CITY PLANNING COMMISSION

- APPLICATION:**
- A. Negative Declaration
 - B. Special Permit to construct a 69 unit apartment complex in the R-2B-PUD zone.
 - C. Variance to the LPPT PUD Guidelines to reduce 15 foot setback requirements for carports to 7 feet.
 - D. Variance to LPPT PUD Guidelines to reduce 25 foot setback for one-story structures to 15 ft.

LOCATION: North side of Rush River Drive, 300+ ft. west of Greenhaven Drive.

P87-287

EXHIBIT A Site Plan

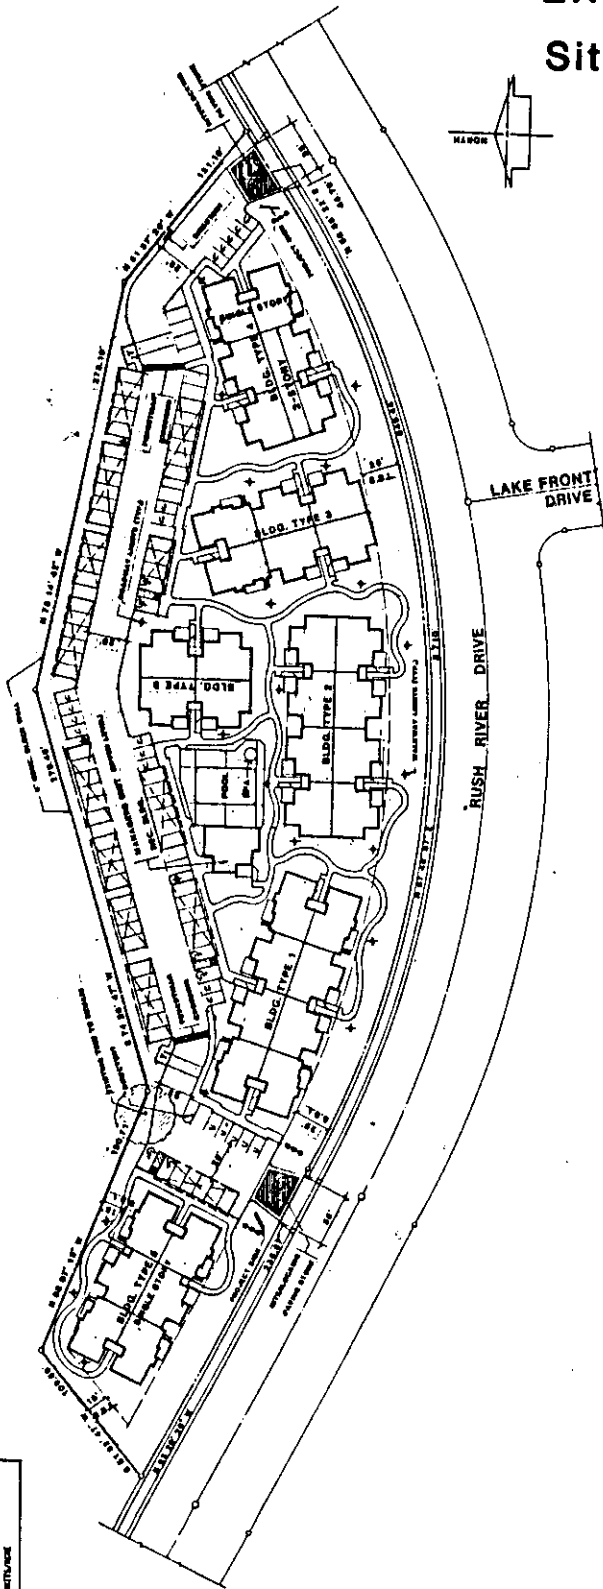
The subject site is irregular in shape and the applicant has designed the site plan so that the covered parking stalls are a minimum of seven feet from the north property line. The LPPT PUD Guidelines indicate that the covered stalls should be a minimum of 15 ft. from adjacent single family residences to act as a noise and visual buffer. The subject site, however, is at a lower grade than the adjacent single family lots and the carport structures will be lower than the lots to the north. The property line on the north runs along the middle of the slope and the applicant has an easement with the present property owner of the single family lots, Citation Homes, to landscape this slope. Planning staff recommends that, in order to minimize the impact of the parking area on future single family residences, the applicant should, if possible, construct the required six foot high masonry wall between the parking lot and the single family homes at the top of the slope and landscape the slope. If this is not possible, staff recommends that the required wall be constructed on the subject site so that it measures six feet from the highest grade of the adjacent single family lots. This height will provide the future residences to the north with an adequate noise and visual buffer. Staff also recommends that the design of the carports be subject to Planning staff review and approval with a decorative feature being incorporated on the top of the carports.

The western portion of the subject site is 109 feet in depth and in order to maintain the required 25 foot landscaped setback along Rush River Drive, a portion of the six unit, one story building proposed for this area is 15 feet away from the north and west property lines. Planning staff recommends that the six foot high masonry wall required for a portion of the north property line be extended along the entire north and west property lines to insure the occupants of these adjacent single family residences their privacy. The wall would not be required in the 25 foot landscaped setback area. The landscape plan indicates a variety of trees and shrubs between the units and the property line which will also act as a noise and visual buffer for the single family residences.

Planning staff noted, while inspecting the subject site, that there is one large oak tree and possibly several small oak trees on the slope that are located on the subject site. All oak trees on the site will be required to be retained and incorporated into the landscape plan.

The submitted site plan indicates several light fixtures along the north property line. These light fixtures need to be screened and oriented away from the adjacent single family lots so they do not produce an annoying glare to adjacent residential uses.

Several of the apartment units have their front doors facing Rush River Drive. Planning staff is concerned that due to the configuration of the buildings and the location of the parking lot at the rear of the site, people will be tempted to park on Rush River Drive and walk across the landscape setback to the apartment units. Staff finds that excess on-street parking would detract from the appearance of the apartment project and produce unnecessary wear-and-tear on the landscaped area. Staff, therefore, recommends that a four foot high decorative wrought iron fence be placed in the 25 foot landscaped setback area in order to discourage unnecessary on-street parking and maintain the appearance of the site.

One hundred and nine (109) parking spaces are indicated on the site plan. Sixty-nine (69) of these spaces are covered. These spaces meet the Zoning Ordinance and PUD parking requirements. Guest parking should be clearly marked and scattered throughout the site. Bicycle parking will need to be indicated on the revised site plan.

- 1. Revised landscape, shading and irrigation plans shall be submitted for Planning Director review and approval prior to issuance of building permits. The revised plans shall indicate minimum four foot high decorative wrought iron fence in the 25 foot landscaped setback area, heavy landscaping between the single story building and the north and west property lines, and shall follow the requirements of the LPPT PUD Guidelines.

- 2. The applicant shall provide a decorative masonry wall between the parking lot and driveway areas adjacent to the north and east property lines. If possible, the applicant shall construct the northern portion of the wall off-site on the adjacent single family lots at the top of the slope and landscape the common slope area of the apartment site and adjacent single family lots. If this is not possible, the applicant shall construct the wall on the subject site so that it measures six feet in height from the highest grade of the adjacent single family lots. Wall design and materials shall be subject to Planning Director review and approval.

- 3. A lighting plan for the project shall be provided and lighting shall be screened and oriented so that it does not produce an annoying glare to adjacent residential uses.

- 4. The applicant shall provide a six foot high decorative masonry wall along the north and west property lines adjacent to the two existing single family residences. A portion or all of this wall may be waived if the adjacent property owners agree. The wall shall not extend into the 25 foot landscape setback area.
